Meeting Date: 9/13/2011

Title: Entertainment & Sports Complex Technical Review Report

Report ID: 2011-00744

Recommendation: Receive and file the Entertainment and Sports Complex ("ESC") project's Technical Review. Provide staff with comments, recommendations, policy guidance and next steps.

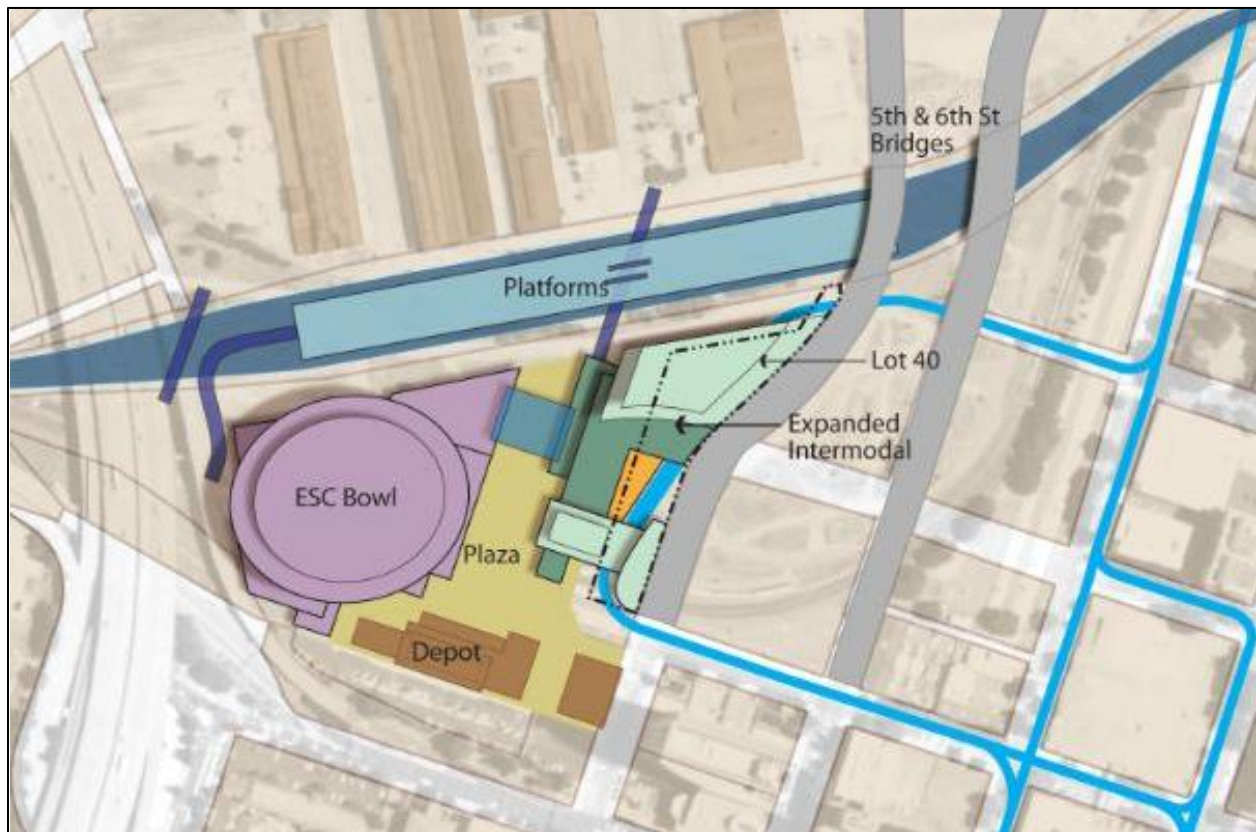
The City Technical Review Team's site concept organized the ESC and the Intermodal hub around a central linear plaza. With two intensive public facilities attracting large volumes of patrons, it is essential to provide public open space to service the needs of pedestrians before and after events. The City's site concept was validated by a committee of ULI experts in July of 2011, and this preferred concept should move forward in the final design phase.

Figure 2 - ESC Entrances: *The proposed location of the truck loading docks (west) and the main entrance (east) facing the plaza and Intermodal facilities.*

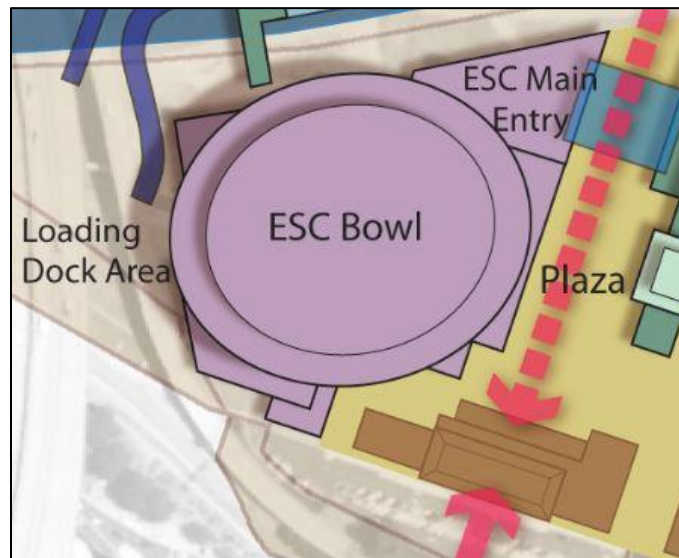
The City Technical Review Team has explored the option to lower the elevation of the ESC in order to mitigate the difference between street (plaza) level and the height of the main concourse. The main concourse is generally thirty-one (31') to thirty-five (35') feet above the event floor. Reducing the height of the concourse pushes the event floor below street level as well as the truck marshalling and loading dock area which must be on the same level as the event floor. Despite the ULI panel's recommendations in July, the City Technical Review Team concept does not currently recommend depressing the facility below grade due to the ground water conditions which exist on the site and the unknown cost impacts. However, further review should be undertaken before a final determination of impacts and benefits of lowering the facility can be assessed.

The internal function of the ESC requires the loading and truck marshalling area coincide with the stage end of the facility for performance venues. It is also customary to have the main entry to the facility opposite the stage end for large performance events. In consideration of these internal function criteria the servicing end of the ESC would remain to the west as proposed by ICON-Taylor. However, to avoid conflict with the access ramps to the passenger rail platforms that are currently under construction, the loading area may be moved to the southwest (refer to Figure 2). The entire area west of the ESC hosts numerous support columns for the Interstate 5 freeway that will need to be considered for circulation and access design.

Figure 4 – Public Plaza: *Proposed public plaza, which establishes a view corridor between the Historic Depot and the Railyards' Central Shops, and acts a gathering place for both ESC events and the Intermodal services.*

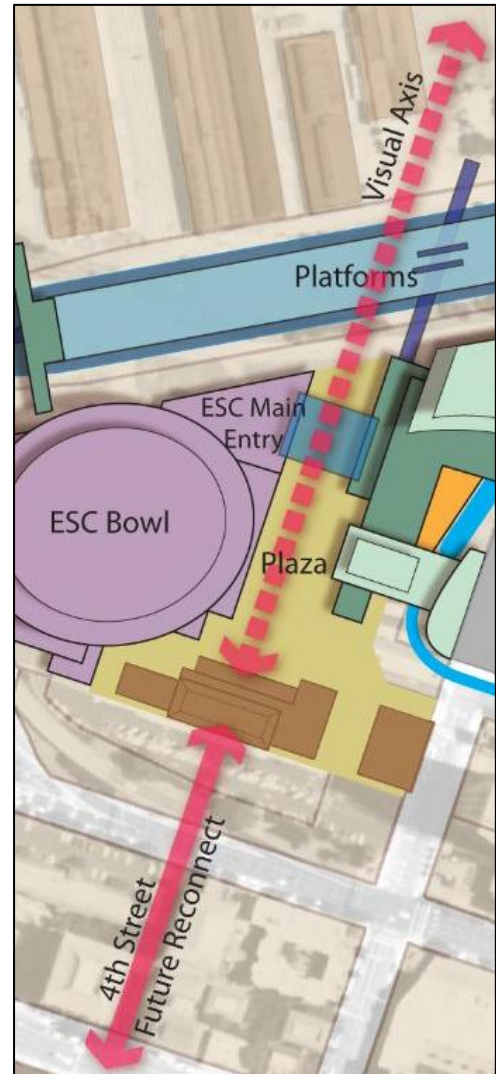
As shown in Figure 4, the central public plaza would align with the predominant axis of the Historic Depot as a visual extension of 4th Street. This would allow a clear visual relationship between the Historic Depot and the new passenger station facilities and Historic Central Shops beyond. Furthermore, it helps avoid having large structures massed directly behind the Depot. This central spine enables the expanded Intermodal facility to develop around a linear pedestrian space defined by the Depot, Intermodal extension and the ESC.

To address the large massing of the ESC, one concept proposed by the City's Technical Review Team allows the linear promenade, extending north from the Depot plaza, to ascend up to the main entry of the ESC on the west flank, and an upper level entry to the Intermodal while giving the patron a broad view of the Railyards' Central Shops buildings beyond and passenger facilities in the foreground. With the rise of the plaza towards the tracks, at approximately sixteen feet above existing grade, accommodation could be made for additional parking serving either ESC or Intermodal patrons. However, any rise in the plaza area would need to ensure that it does not block the public's views of the Historic Depot and Central Shops which are key assets of the area.
